HIGHLANDER

OUTLINE OF NEW FEATURES

3. Exterior Color

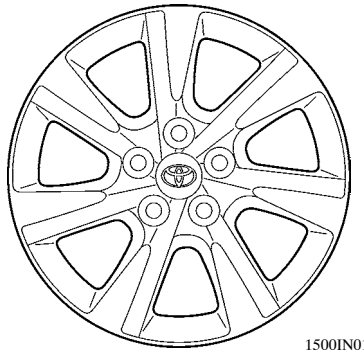
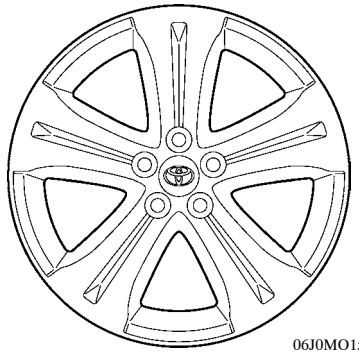
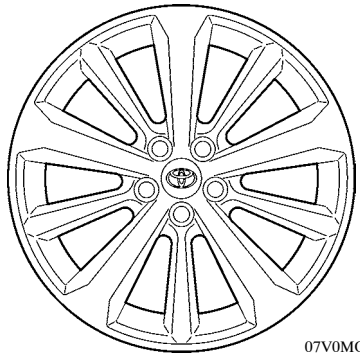
There are a total of 9 exterior colors – 6 carryover colors and 3 new colors:

Color No.	Color Name	Note
070	White Pearl Crystal Shine	Carryover
1F7	Silver Metallic	Carryover
1G3	Gray Metallic	Carryover
202	Black	Carryover
3R0	**Blackish Red Mica**	**New**
4T8	Beige Metallic	Carryover
8S6	**Dark Blue Mica**	**New**
8T7	Blue Metallic	Carryover
8V5	**Grayish Blue Mica Metallic**	**New**

4. Tire and Wheel

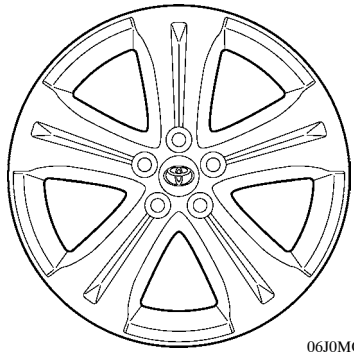
- The 17-inch aluminum wheel design for models for Australia has been changed.

: Changed

Tire Size		245/65R17	245/55R19
Wheel	Size	17 × 7 1/2J	19 × 7 1/2J
	Material	Aluminum	Aluminum
	Color No.	11SV14	11GY02
P.C.D.*	mm (in.)	114.3 (4.5)	114.3 (4.5)
Inset	mm (in.)	35 (1.4)	35 (1.4)
Wheel Design		 1500IN01C	 06J0MO15C
Equipment	N	Standard	Option
	GRANDE	—	—

Tire Size		245/55R19
Wheel	Size	19 × 7 1/2J
	Material	Aluminum
	Color No.	11SV14
P.C.D.*	mm (in.)	114.3 (4.5)
Inset	mm (in.)	35 (1.4)
Wheel Design		 07V0MO07C
Equipment	N	Option
	GRANDE	Standard
